Project #21-064 Cache County Food Pantry Located at 359 South Main Street

REPORT SUMMARY...

Project Address:359 South Main StreetRequest:Design Review PermitCurrent Zoning:Commercial (COM)Date of Hearing:October 28th 2021Type of Action:Quasi-Judicial

Submitted By: Russ Holley, Senior Planner

Figure 2 shows the proposed building

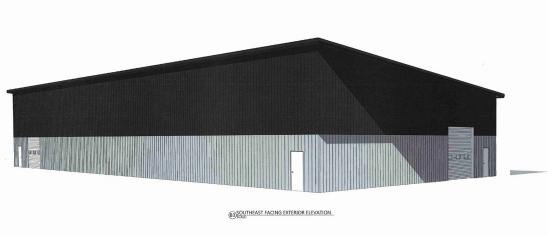
The LDC 17.10.080 states that commercial buildings should be designed to promote high-quality developments with 30% transparency along street facing facades, walls breaks/articulations every 40 linear feet and inviting four-sided architectural design. The proposed metal warehouse building does not have street facing facades and does not show any wall articulations. The building does show a color break halfway up the wall around the entire building. If the color changes are deemed acceptable wall breaks, the building design complies with LDC standards as proposed.

- 4. Landscape shall be added to the north and west setback area where paving is currently shown.
- 5. The Planning Commission considers the color changes acceptable breaks in the building design because of the location and use of the building. The street facing 30% fenestration requirement is not applicable on this portion of the site.
